Staff Report Addendum

Tentative Subdivision Plat and Minor Variance

SD-03-23 & VR-03-24

May 24, 2024

Approved Phase Line:

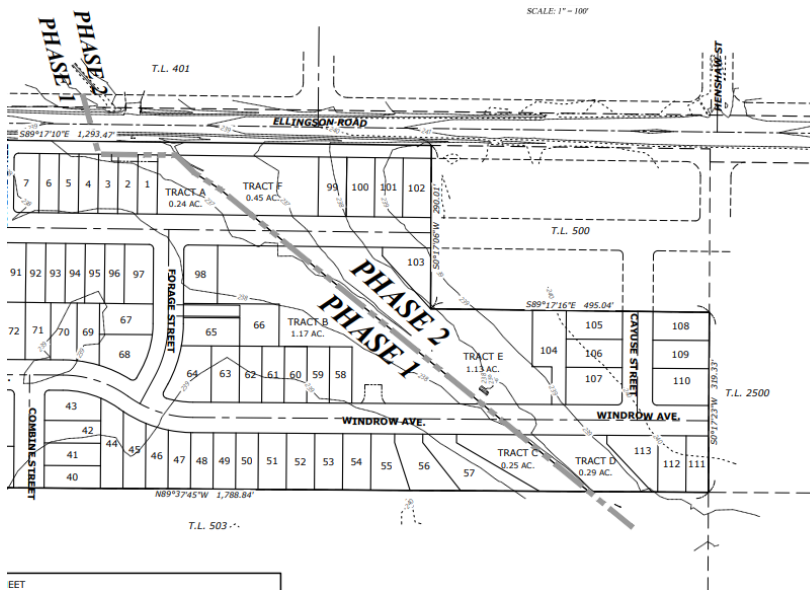
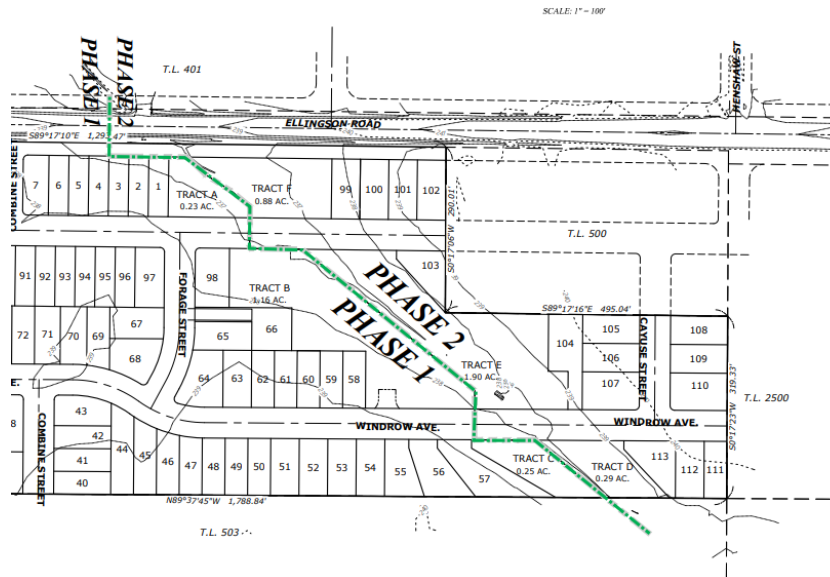
The applicant provides a revised phase line “due to conversations with staff and Conditions of Approval”. This Phase line revision does not affect the number of lots within each phase or street connections.

Revised Phase Line: Due to conversations with staff and Conditions of Approval, the applicant is proposing to revise the Phase 1/Phase 2 phase line. This Phase line revision does not affect the number of lots within each phase or street connections. See attached site plans.

Staff does not recommend approval of this revised phase line. It is intended to defer the Conditions of Approval discussed above to the second phase.

WATERLINE PLAN - NORTH

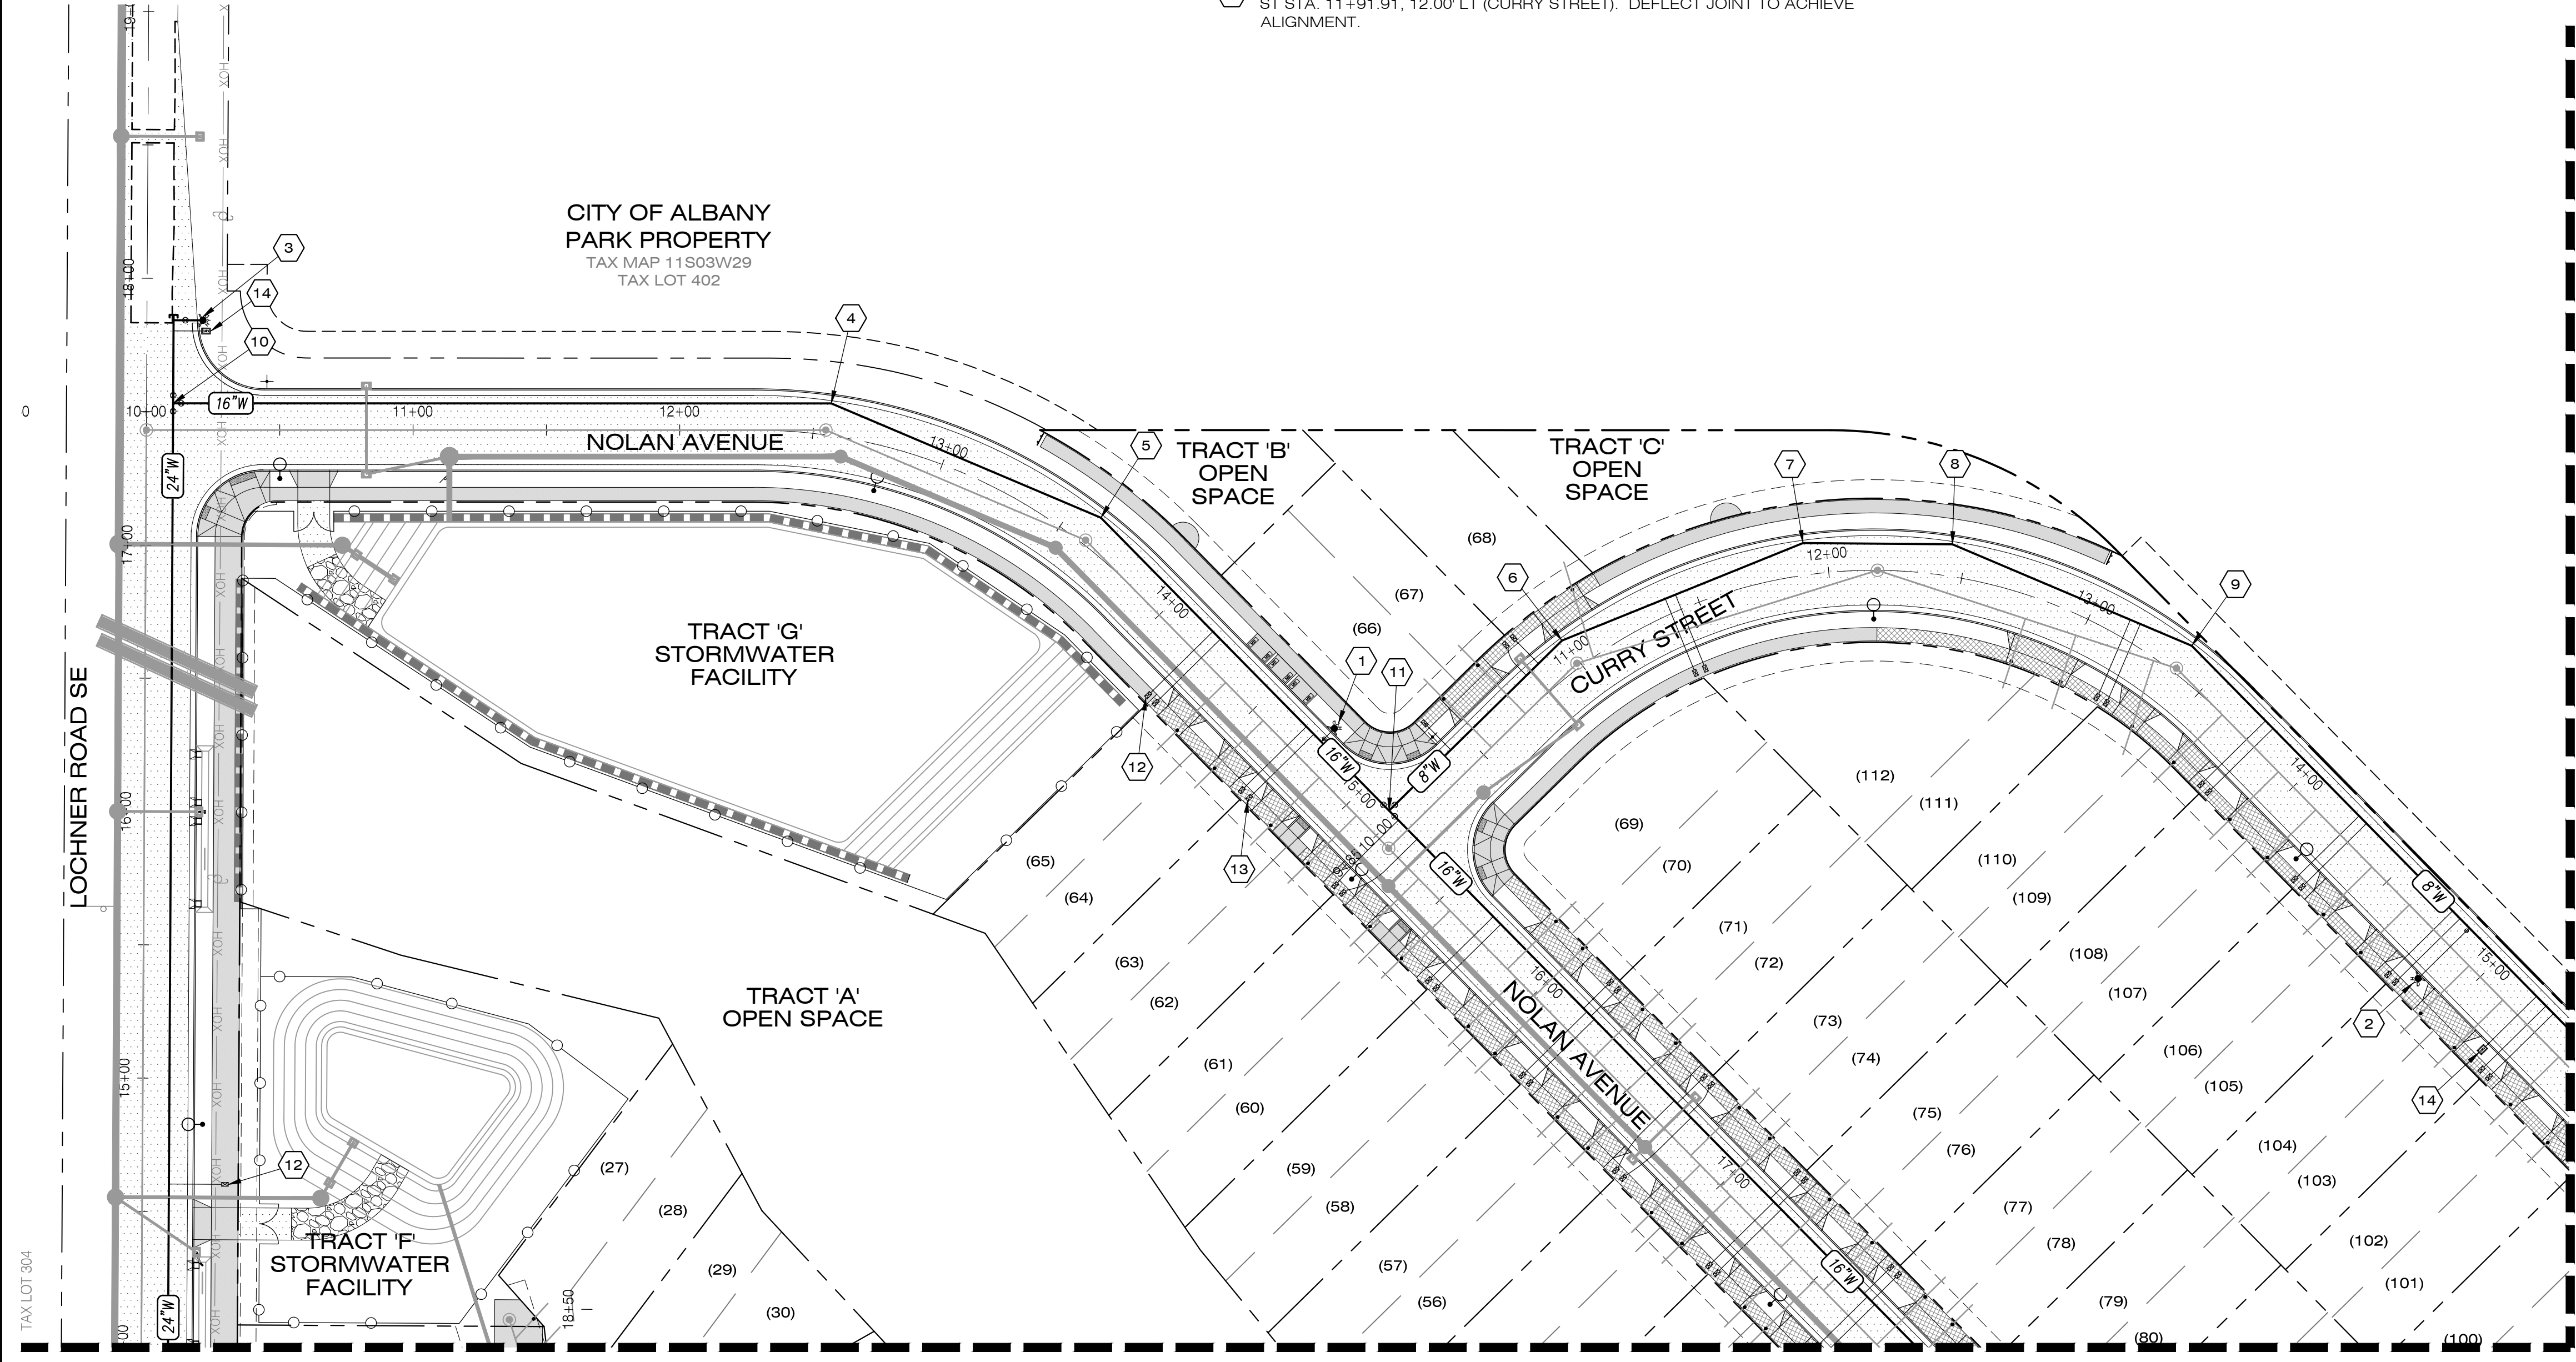
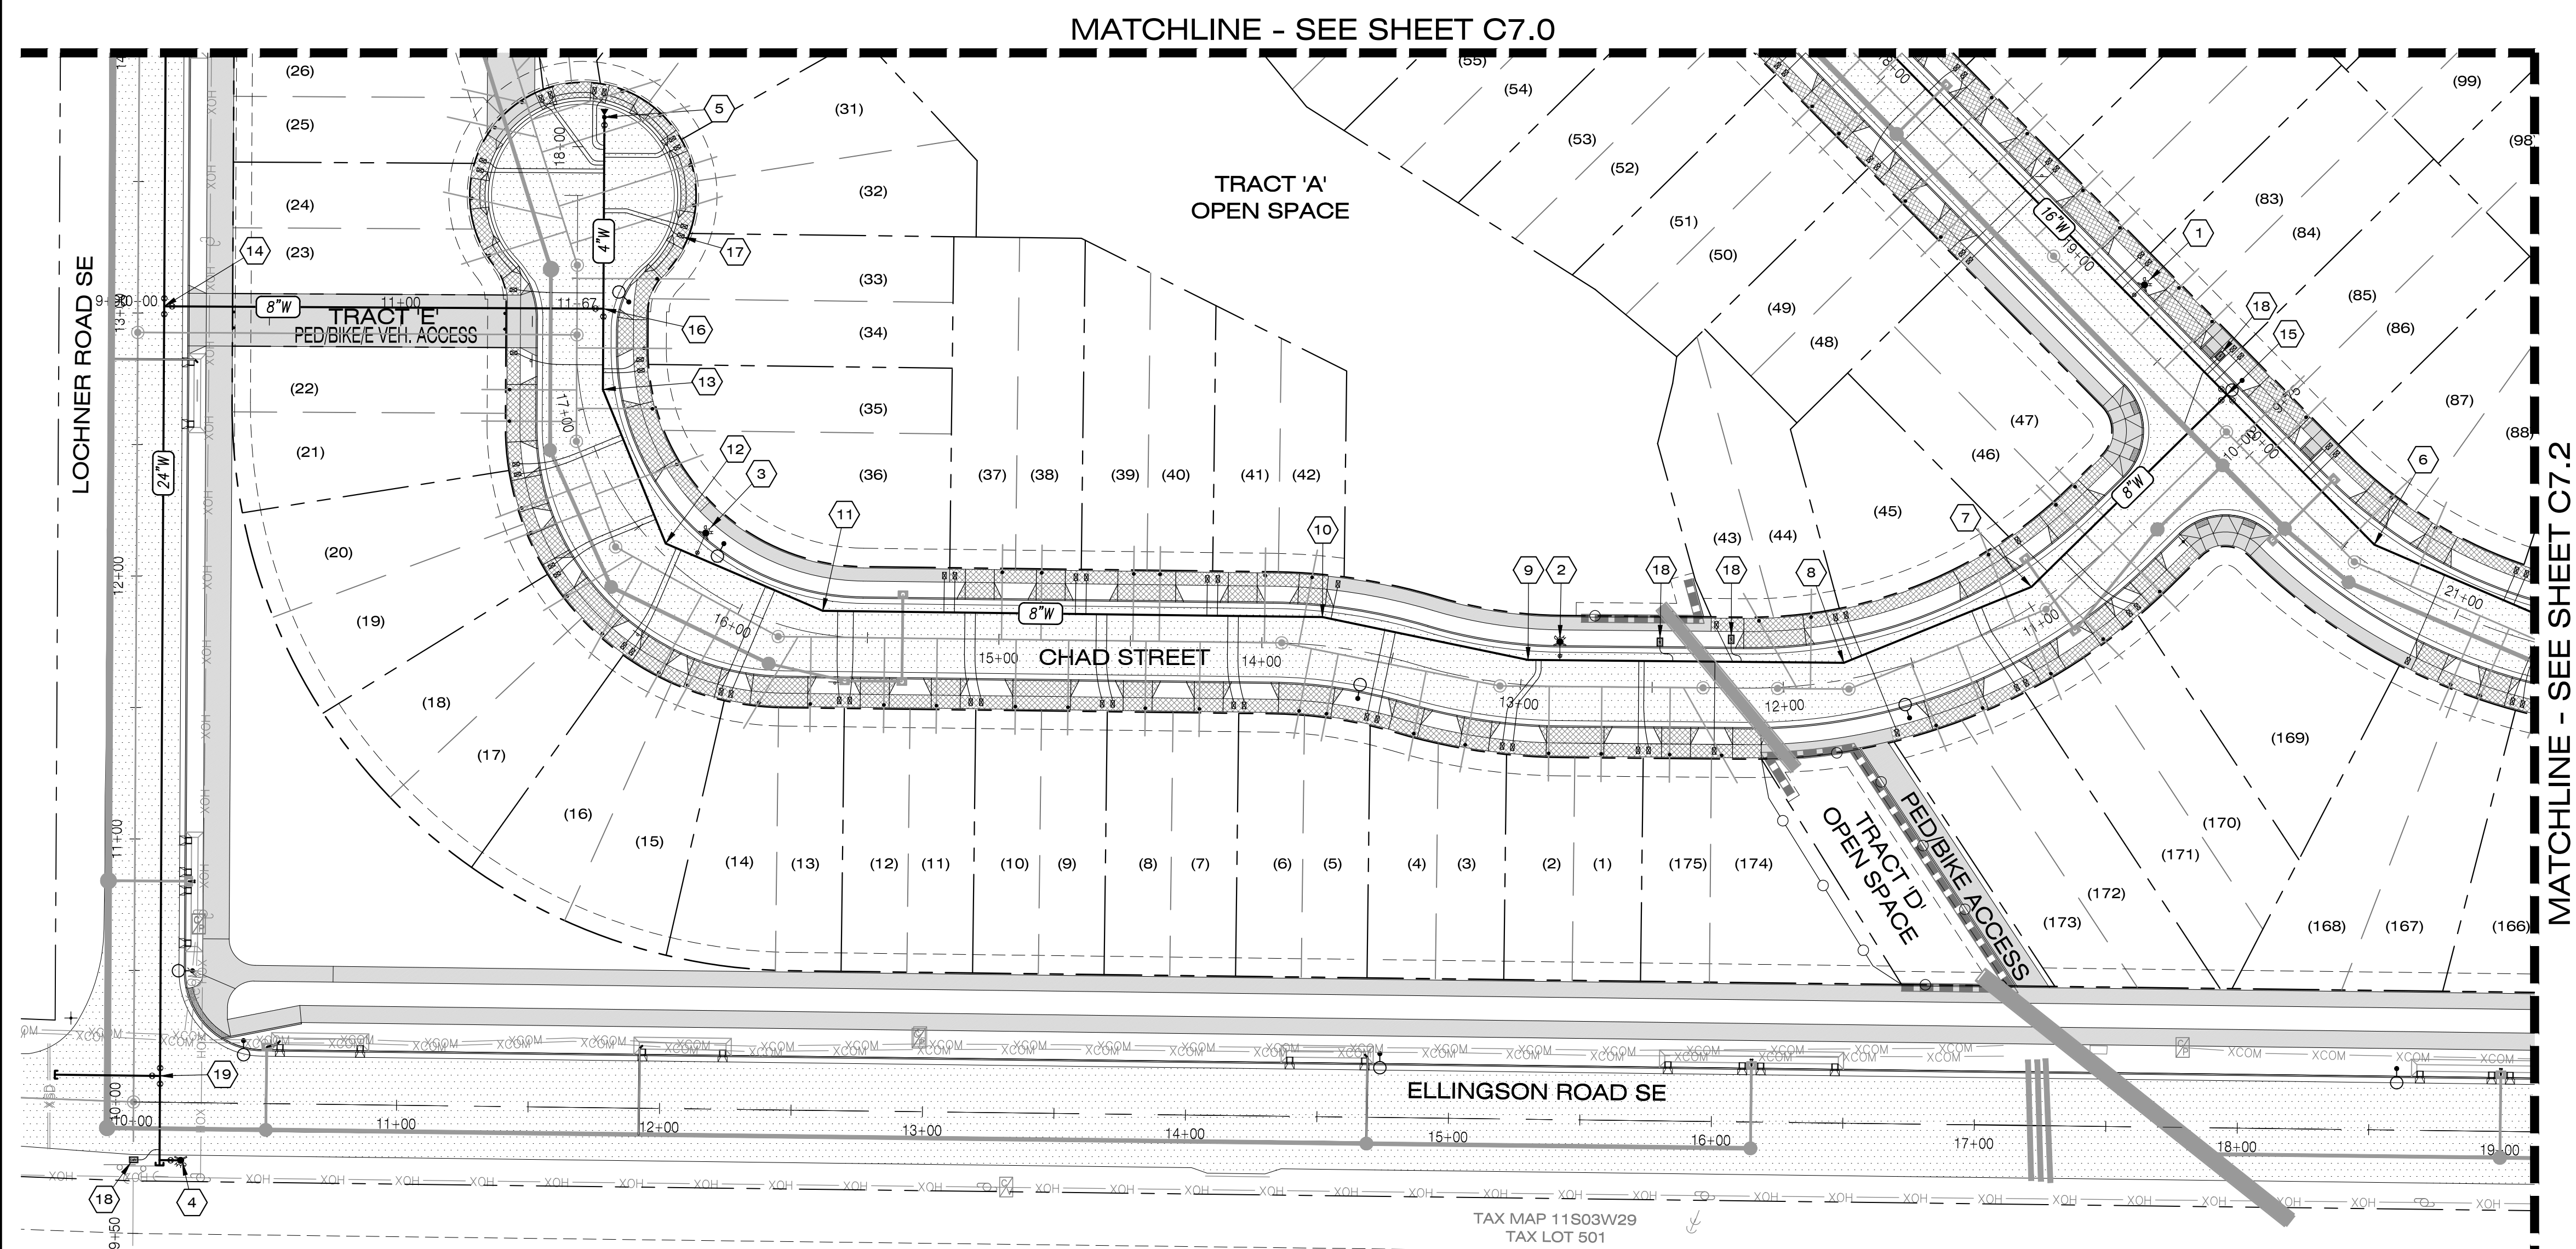
We are confused by this condition with what we understand is occurring on the north side of Ellingson Road regarding water master plan facilities.

Reviewing the Curry Meadows plans along with the Henshaw Farms project, a 16" water main is being constructed from the 24" water line in Lochner Road to Columbus Road. (some of the Curry Meadows water plan is attached)

We need Public Works to provide a much better explanation of the requirement and clarification of this projects responsibility.

Good morning Brian,
The water line is required for Curry Subdivision and is part of their plans to get it to the Lochner and Ellinson intersection. The timing of that work starting and being completed is unknown.
